Re: Comments and Contested Case Hearing Request Regarding Blizexas,
LLC proposed Texas Land Application Permit (TLAP) No. WQ0016111001

Blizexas, LLC, 258 Union Avenue, Los Gatos, California 95032, has
applied to the Texas Commission on Environmental Quality (TCEQ) for a
new permit, proposed TCEQ Permit No. WQ0016111001, to authorize
the disposal of treated domestic wastewater at a daily average flow not
to exceed 12,000 gallons per day via subsurface drip irrigation system
with a minimum area of 2.75 acres of public access land.

Fig. 2: Fitzhugh Music Venue: diagonal lines show 6 small TLAP fields surrounded by impervious cover

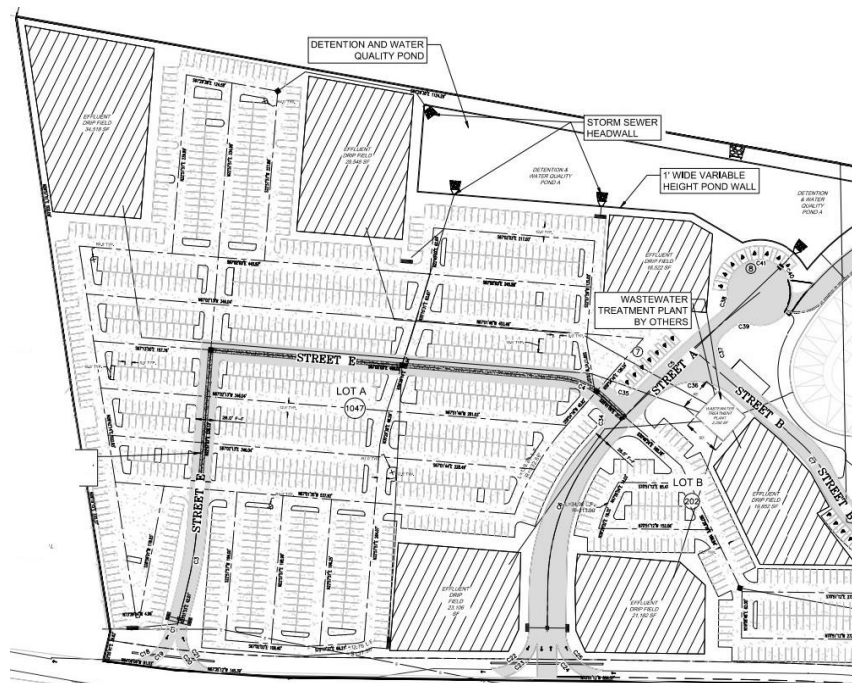
Aside from concerns over pollutant limits, the layout of the proposed Fitzhugh Music Venue itself is also problematic from a wastewater standpoint. The developer has proposed 6 relatively small (roughly ½ acre each) effluent drip fields comprising a total of 2.75 acres. Each TLAP field would be surrounded by impervious cover (Fig. 2). This means that even light precipitation would cause runoff of wastewater that could threaten not only Barton Creek but surrounding properties as well.

At a bare minimum, GEAA recommends a 5-5-2-0.5 permit for the Fitzhugh Music Venue wastewater treatment plant: 5 mg/l TSS, 5 mg/l BOD, 2 mg/l Ammonium Nitrate, and 0.5 mg/l Phosphorous, rather than the very lax 20/20 permit levels for TSS/BOD that were given in the draft permit (with no Nitrogen or Phosphorous limits).

Fig. 3: Fitzhugh Music Venue's area is mostly impervious parking spaces, asphalt driveways, and concrete

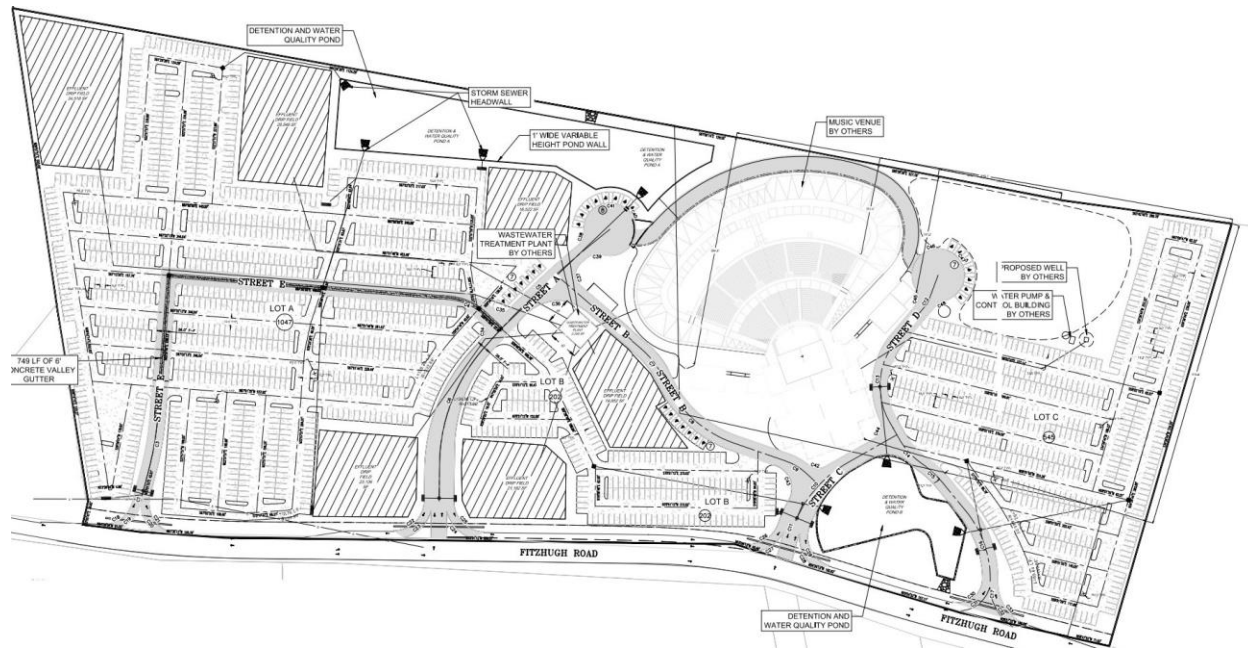
While the lax draft Fitzhugh Music Venue wastewater permit is concerning, perhaps an even bigger environmental issue is the high amount of impervious cover the developer has proposed, 66.45% (Fig. 3). A heavily paved development with high impervious cover such as what is proposed would be more typical in an urban setting than in a rural area with an important contributing stream (Barton Creek) nearby.

While the impervious cover percent is certainly too high for this area, the type of impervious cover is even more troubling. Most of the impervious cover is allocated for the 1,823 parking spaces in the proposed sprawling parking lot. These parking spaces would be subject to auto pollutants leaking from parked vehicles; pollutants including engine oil, gasoline, power steering fluid, brake fluid, heavy metals from car batteries, and tar-based sealants that protect parking lots and asphalt driveways. The applicant also plans to construct asphalt driveways, fire

Fig. 4: Drainage diagram shows roughly half of the combined wastewater/stormwater runoff would miss the two batch detention ponds and wind up in Barton Creek

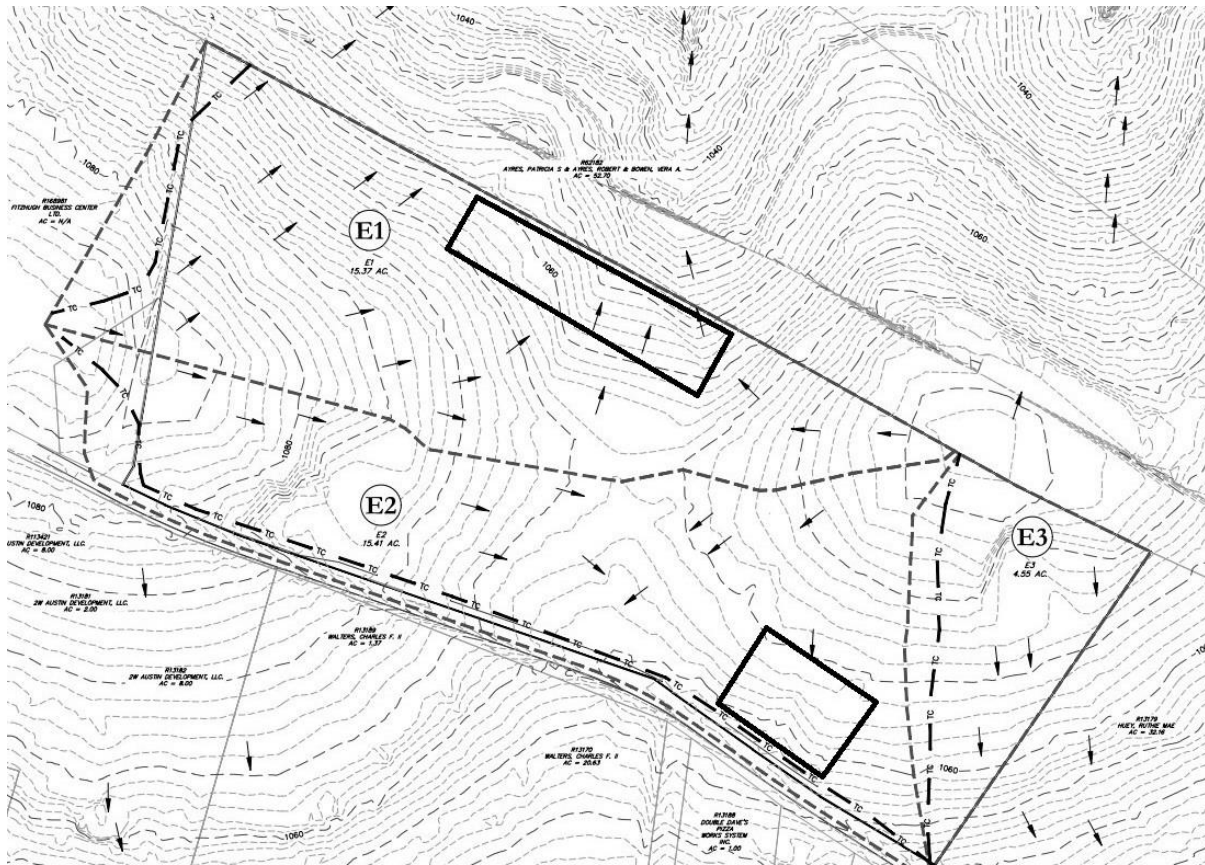
Yet Fig. 4 shows the problem with this approach. The property consists of three separate drainage basins, shown as E1, E2, and E3 below. The two bold rectangles show the approximate locations of the proposed batch detention ponds that are supposed to collect the combined

wastewater/stormwater runoff. Basin E1 drains approximately 30% of its area to the left of the first detention pond, sending runoff downhill to Barton Creek. Basin E2 has flow from left to right but also from top to bottom of the diagram; these competing directions will combine basin flow into one stream, much of which will likely miss the second batch detention pond. Lastly, the third basin (E3) has no batch detention pond to collect runoff, assuring that this runoff from Basin E3 will also end up in Barton Creek.

Because the entire development is in the Barton Creek watershed, there's nowhere else for the runoff that misses the batch detention ponds to go. Given the location and size of the batch detention ponds shown in Fig. 4, roughly half of the runoff will miss the batch detention ponds and wind up in Barton Creek.
